**AGENDA
CITY PLANNING COMMISSION
CITY OF LIVONIA
Tuesday, August 11, 2026**

1. Petition 2026-06-01-02, submitted by Guggenheim Development, LLC, pursuant to Section 13.15 of the Livonia Zoning Ordinance, as amended, requesting to rezone the property at 32520 Seven Mile Road from C-1 (Local Business) to C-2 (General Business) to allow for an automobile and light truck repair facility (Jiffy Lube), located on the north side of Seven Mile Road between Shadyside and Mayfield Avenues in the southwest ¼ of Section 3.

PLANNING COMMISSION STAFF NOTES

SHEET C200

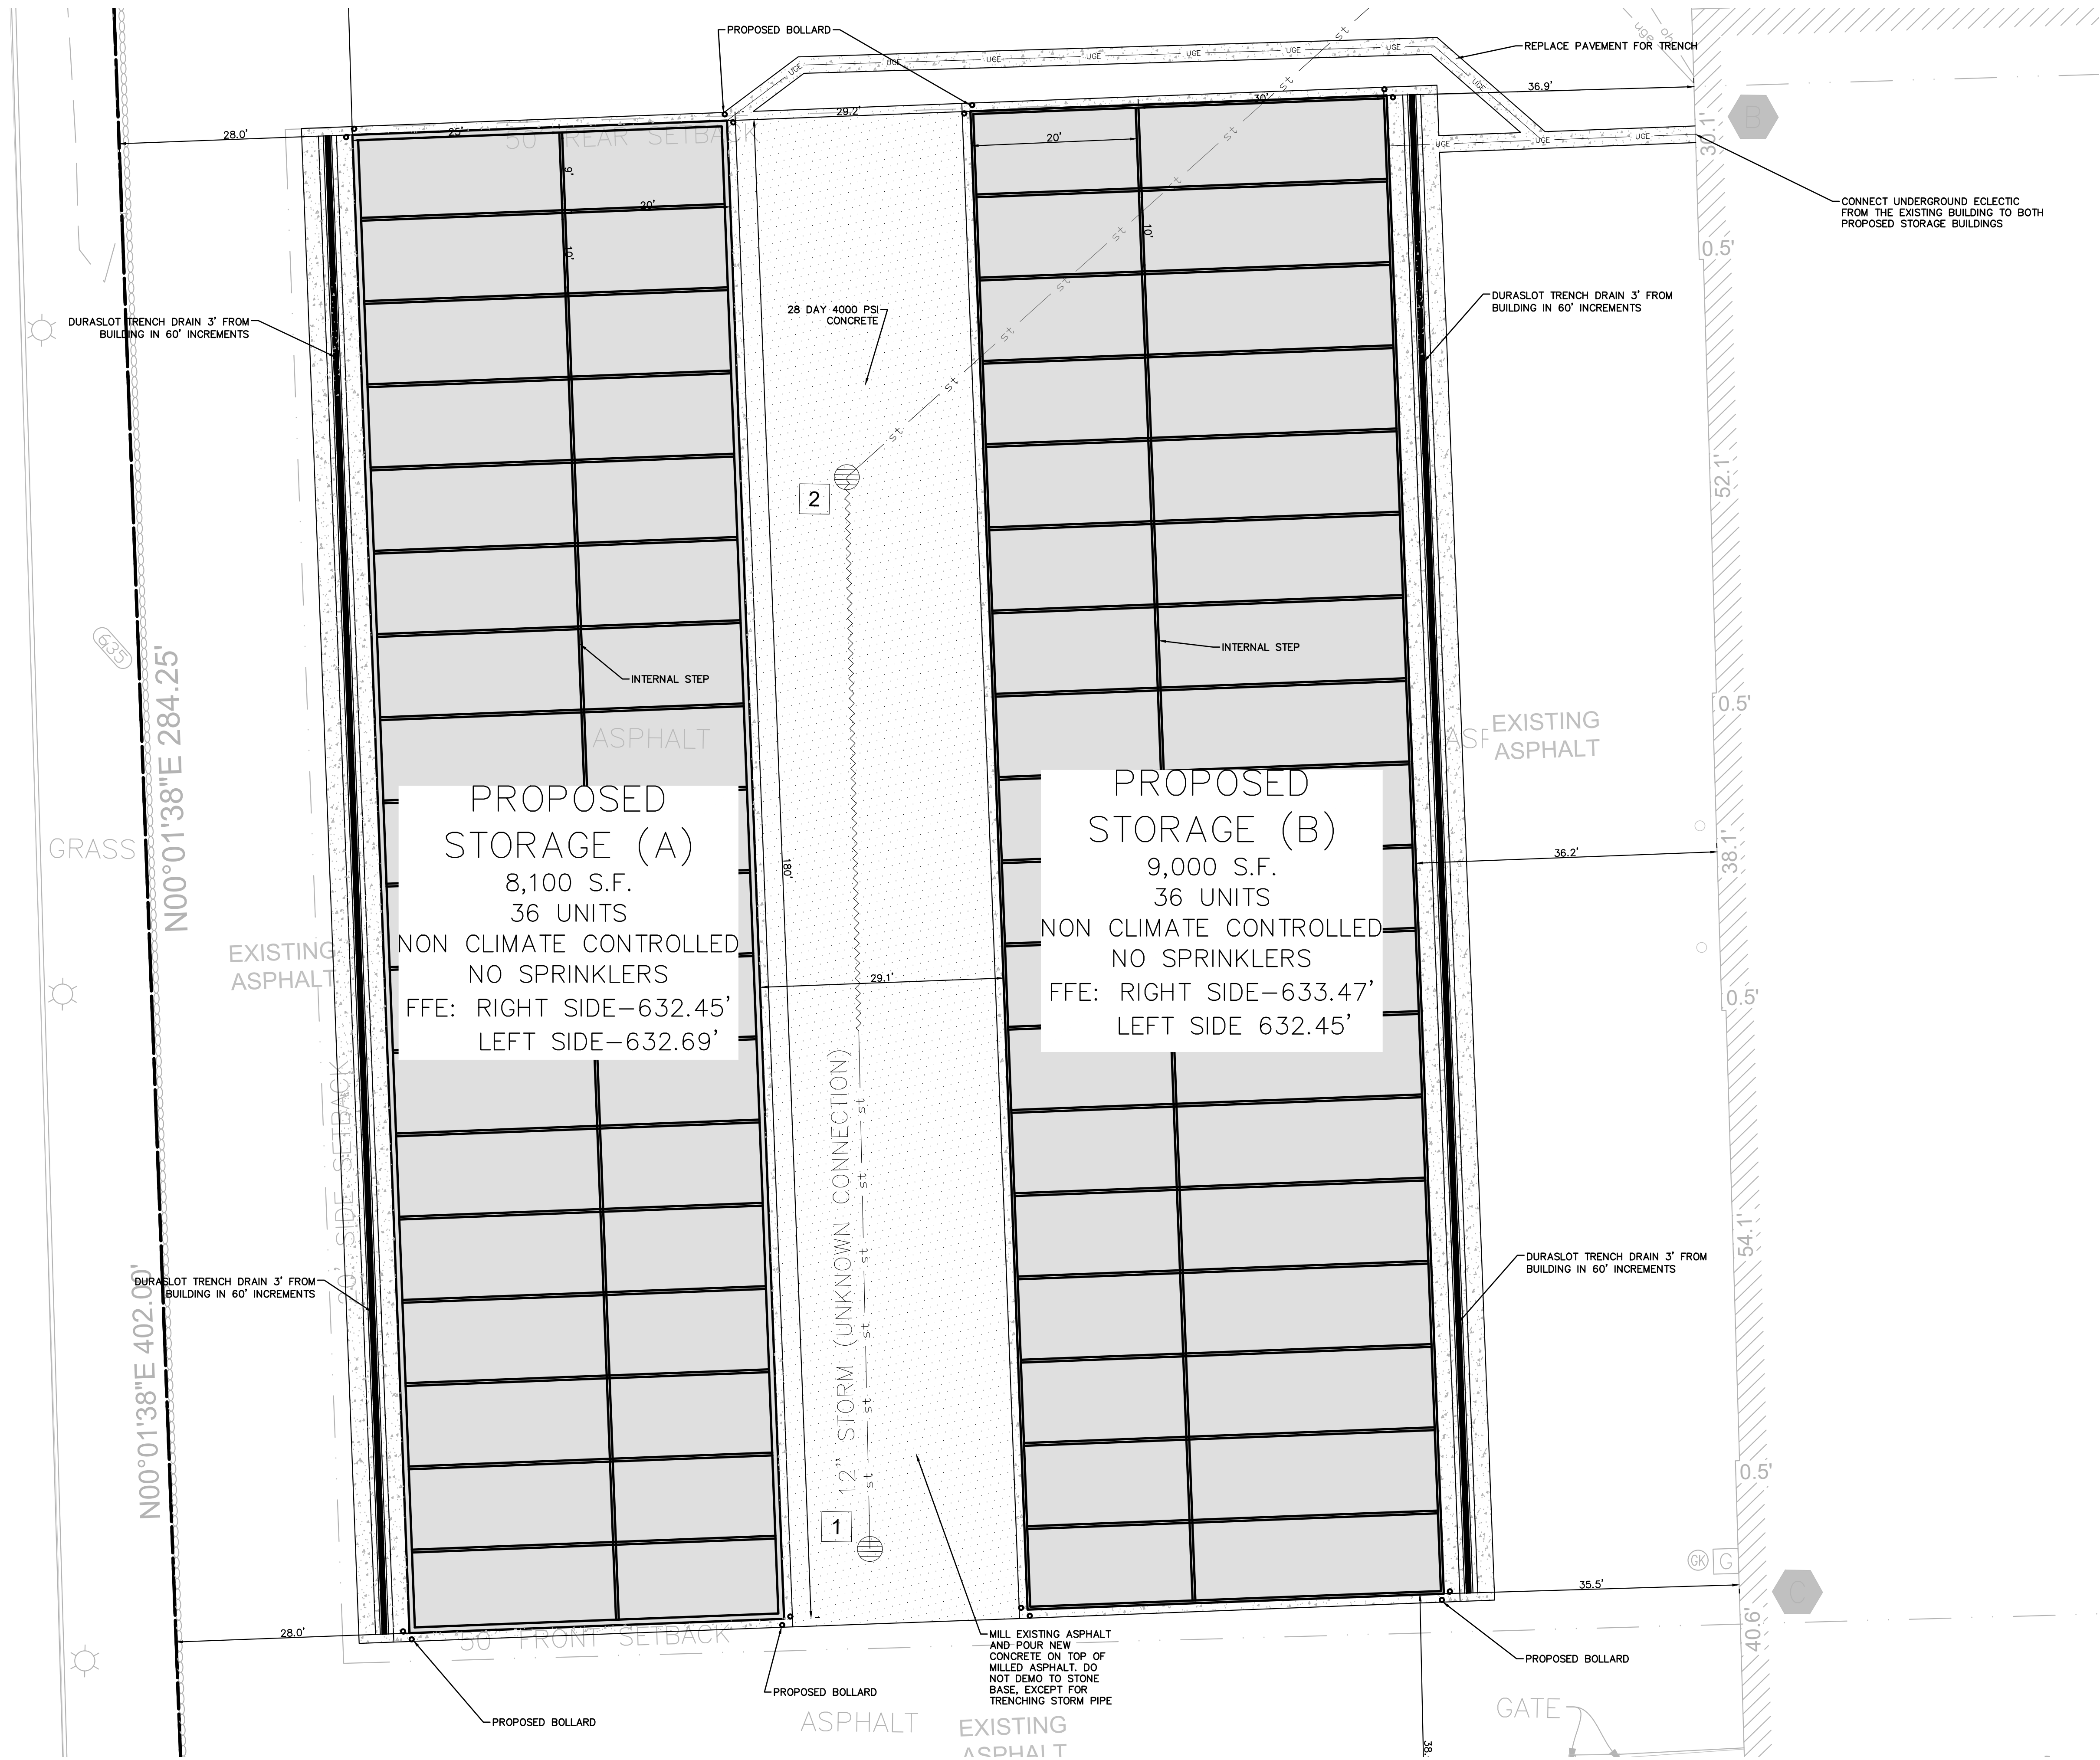
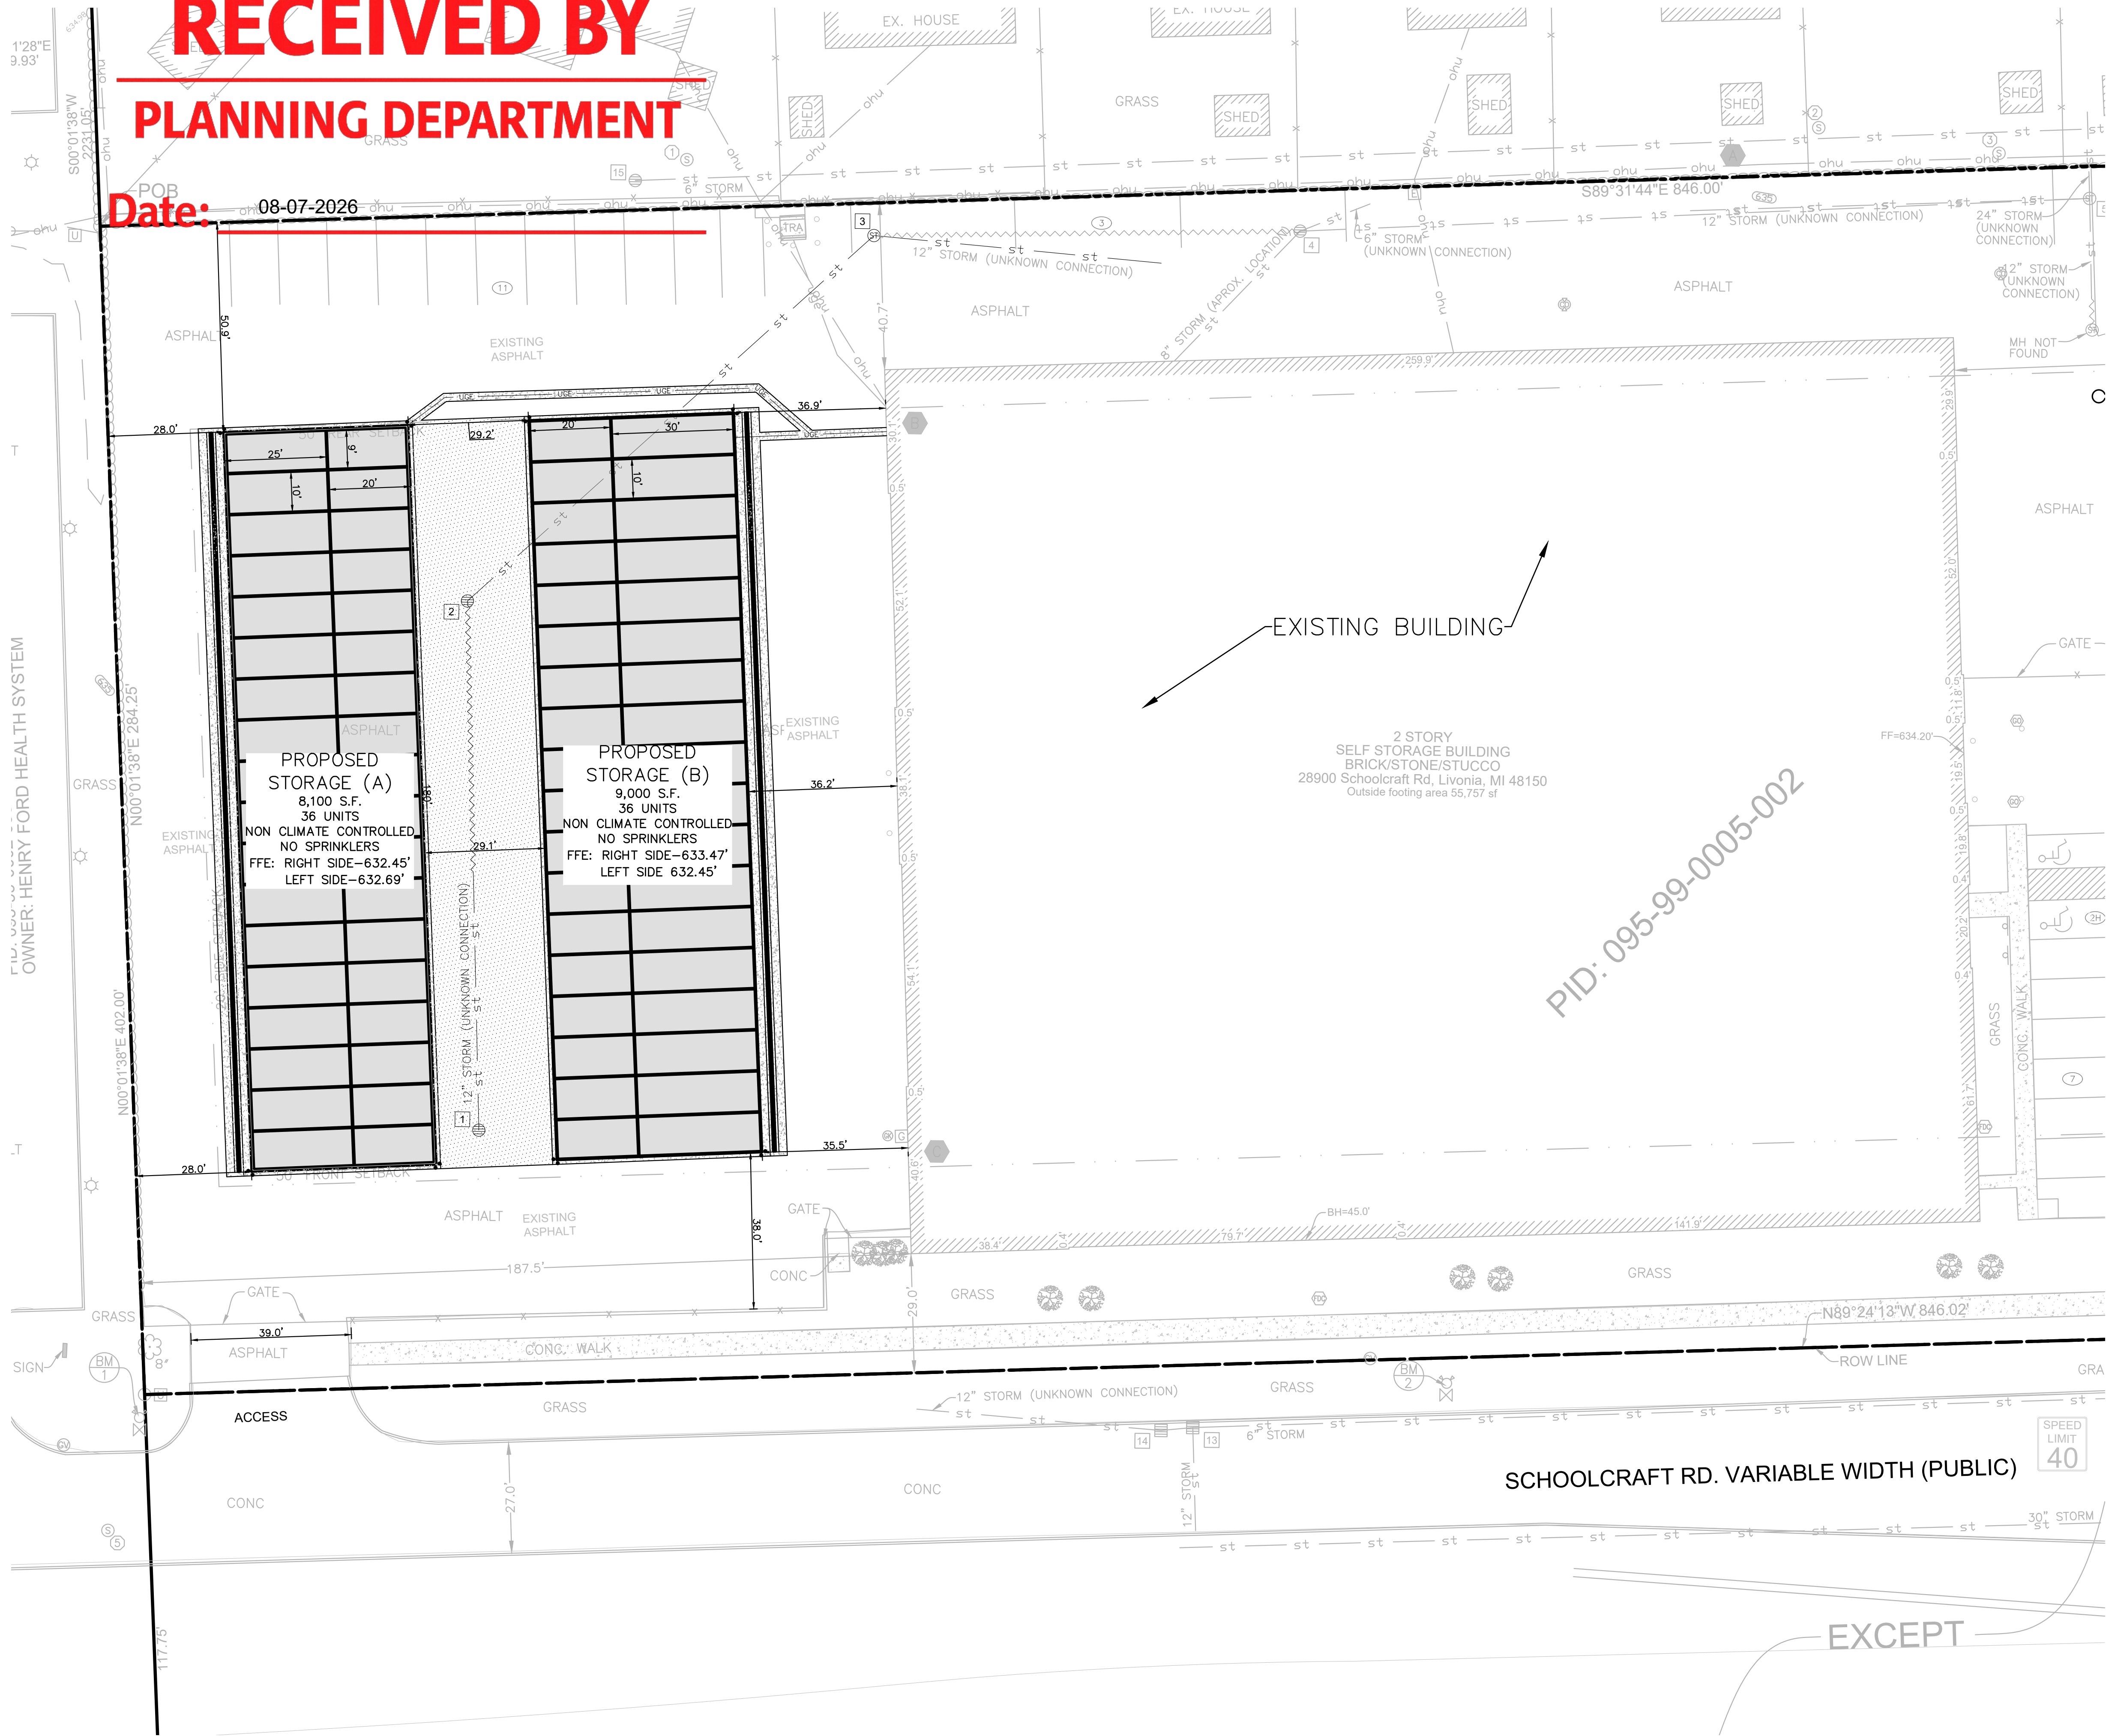
Currently, the site plan lacks sufficient detail regarding the layout and designation of parking areas. Specifically, it is unclear where standard customer and employee parking will be located, and whether separate accommodations are proposed for recreational vehicle (R/V) storage or U-Haul/truck parking. If such uses are intended, they must be clearly identified and differentiated from required parking spaces to avoid conflicts in circulation and availability. CR #207-16 states that the site will have no more than 137 recreational vehicles, including motorhomes, travel trailers and boats, and the storage of all RV's shall take place within the spaces designated on the approved site plan. The proposed buildings would reduce the available RV parking spaces by twenty-eight (28).

unobstructed corner radii at key circulation points. Consideration should also be given to designated loading and staging areas that allow vehicles to maneuver without impeding through traffic. If these elements are not properly integrated into the site plan, the addition of the buildings may negatively impact circulation efficiency and could create safety concerns for both drivers and pedestrians on the property.

New plans have been received by staff including color rendering and lighting plans. **NOTE TO COMMISSIONERS:** *New plans are included in the epacket but staff did not have time to review and modify the staff report with changes before they are to be sent out.*

1. That the Site Plan marked Sheet C200, prepared by Contineo Group, dated July 16, 2026, as revised, is hereby approved and shall be adhered to.
2. That the Landscape Plan prepared by Murphy and Associates, dated April 5, 2016, as revised, is hereby approved and shall be adhered to, except that additional full-size deciduous trees shall be planted along the front of the property subject to approval by the Planning and Engineering Departments.
